VSP-75

VENDOR SERVICE PUBLICATION

SUBJECT: Avco Lycoming Service Letter No. L218 and Service Instruction No. 1059C, No. 1110C and No. 1257E

DATE: April 10, 1987 **Service Instruction No. 1110C**
(Supersedes Service Instruction No. 1110B)
Engineering Aspects are
FAA Approved

Typical Adapter Installation

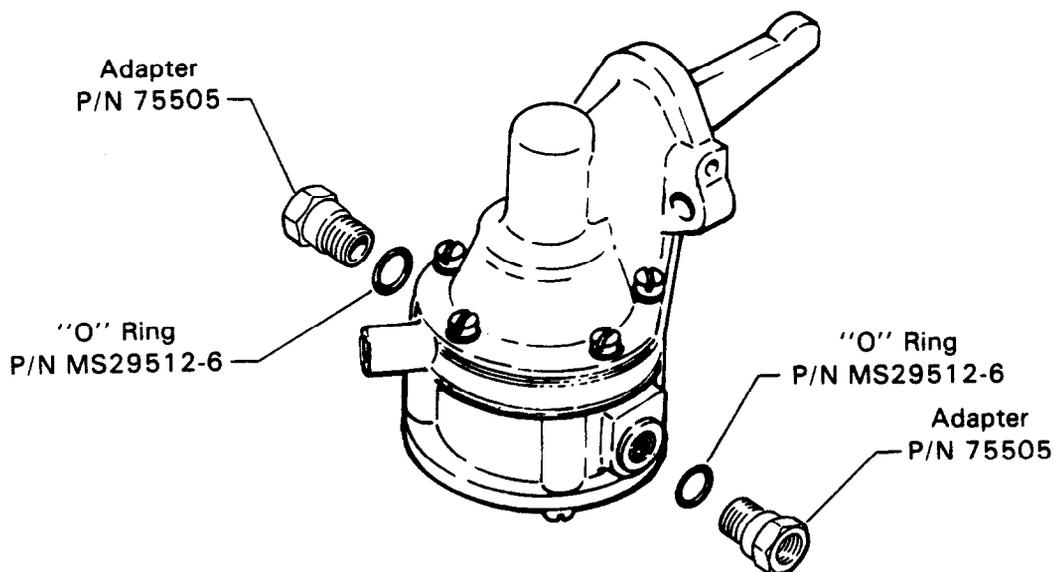
When replacing certain older AC diaphragm type fuel pumps, AC P/N 40174 or P/N 56999 (tapered pipe thread inlet and outlet ports) with a new pump incorporating straight thread ports, an adapter P/N 75505 is available to adapt the pipe thread fittings to the new pump. All newer types of fuel pumps incorporate straight thread ports.

When the older model fuel pumps are replaced with new models, 2 Adapters P/N 75505 and 2 "O" Rings P/N MS29512-6 (one for each adapter) must be ordered separately for proper installation.

Figure 1.
Carburetor Showing Area to be Machined

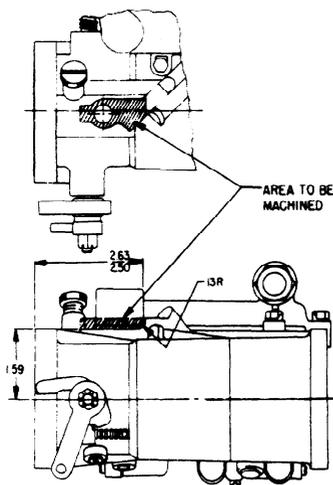
Because of the increased size of the new AC fuel pumps, certain engine models using P/N LW-16335 fuel pump with rear mounted carburetors must have the carburetor reworked to remove the back suction economizer boss. (If not already accomplished or prior to installation of new P/N LW-16335 fuel pump.) See Table 1. Using suitable equipment machine this boss as shown in Figure 1. Also, because of the increased size of the new fuel pump, certain dual magneto engine models must have the accessory housing reworked. See Table 2. Again, using suitable equipment, machine the boss on the accessory housing as shown in Figure 2.

Carburetor P/N's to be Reworked	Installed in Engine Models
LW-15957	O-360-A2G, -A4K, -A4G, -A4J
LW-15958	O-320-D1D
LW-15959	O-360-A1G6; LO-360-A1G6D

Figure 2.
Accessory Housing Showing Area to be Machined

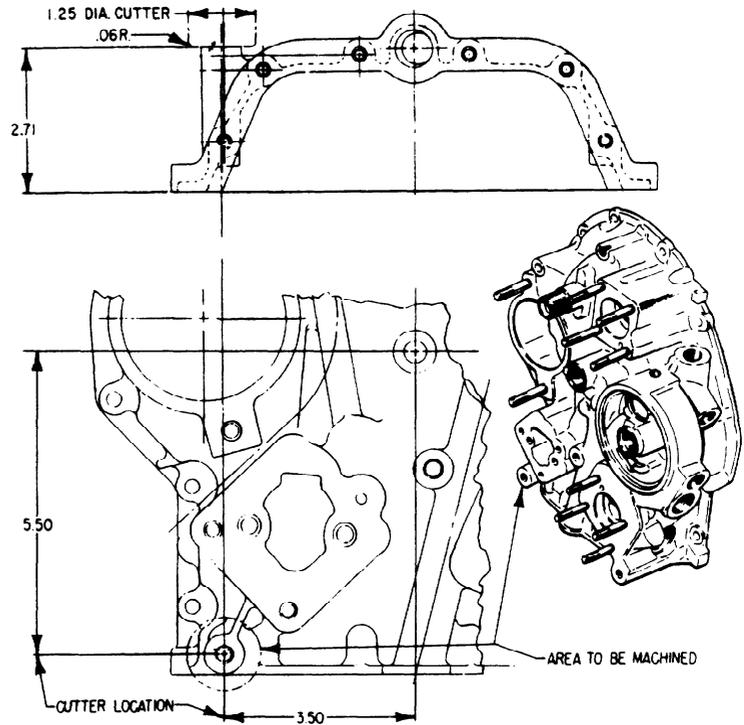
Dual Magneto Accessory Housing P/N's to be Reworked	Installed in Engine Models
LW-10886	O-360-A1G6D
LW-10894	LO-360-A1G6D
